# Federal Register

**National Emission Standards for  
Hazardous Air Pollutants for Source  
Categories: Organic Hazardous Air  
Pollutants From the Synthetic Organic  
Chemical Manufacturing Industry and  
Other Processes Subject to the Negotiated  
Regulation for Equipment Leaks; Final  
Rule**

[AD-FRL-6923-8]

**ACTION:** Final rule; amendments.

Figure 1. ALTERNATIVE EXPERIMENTAL METHODS FOR DETERMINING THE FRACTION OF ORGANIC COMPOUND BIODEGRADED (Fbio) IN A BIOLOGICAL TREATMENT UNIT

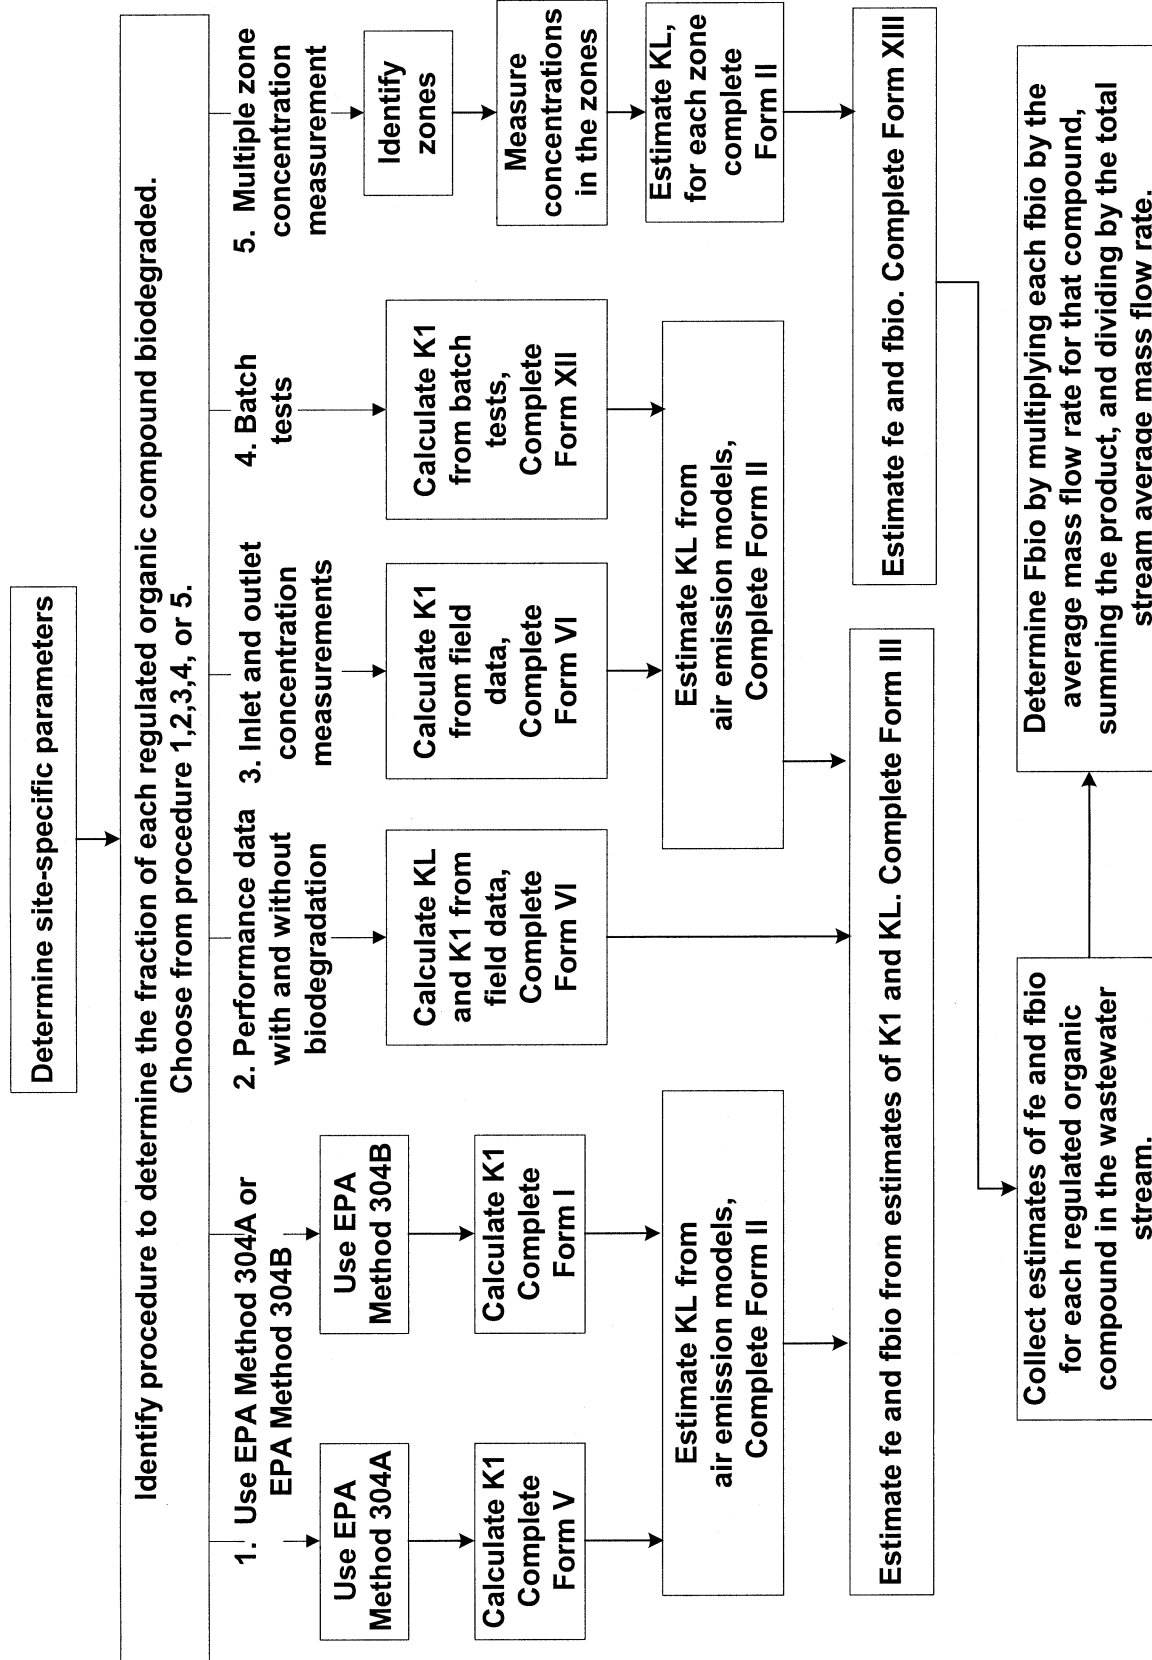
g. Revising Figure 1; and

performance data on a biotreatment unit prior to and after addition of the microbial mass. An example where Procedure 2 could be used is an activated sludge unit where measurements have been taken on inlet and exit concentration of organic compounds in the wastewater prior to seeding with the microbial mass and startup of the unit. The flow chart in figure 1 outlines the steps to use for each of the procedures.
